Intel[®] Pentium[®] II Xeon[™] Processor Specification Update

Release Date: January 2002

Order Number: 243776-032

The Pentium[®] II Xeon processor may contain design defects or errors known as errata that may cause the product to deviate from published specifications. Current characterized errata are documented in this Specification Update.

Figure 1. An Example of Microcontroller Driven Thermal Management

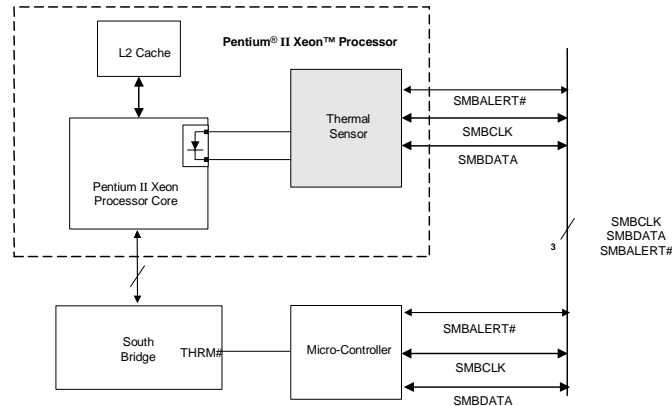
D30. Thermal Sensor May Assert SMBALERT# Incorrectly

Problem: The Pentium II Xeon processor has a thermal sensor that monitors the processor core's temperature. The thermal sensor asserts SMBALERT# if the processor temperature exceeds the temperature limits set in the Alarm Threshold Registers (T_{HIGH} , T_{LOW}). It also sets the corresponding Status Register bits to identify the cause of the interrupt. Figure 1 gives one example of the how the SMBALERT# signal could be used in a system.

Under the conditions described below, the thermal sensor incorrectly generates the SMBALERT# interrupt. *All* of the following conditions must be met to trigger a false interrupt:

Workaround: Three different (mutually exclusive) workarounds are possible:

1. Before servicing an interrupt from the thermal sensor, read and compare the processor thermal reading with the threshold limits (T_{HIGH} or T_{LOW}). Figures 2 and 3 provide basic flowcharts for the implementation of this workaround in an interrupt driven system.
2. If the firmware implemented polls the Status Register only, then before taking any action, re-read the temperature register and do a comparison with the alarm threshold limits (T_{HIGH} or T_{LOW}) to determine if the value is actually still within the temperature window.
3. Use a temperature polling scheme to monitor the processor temperature
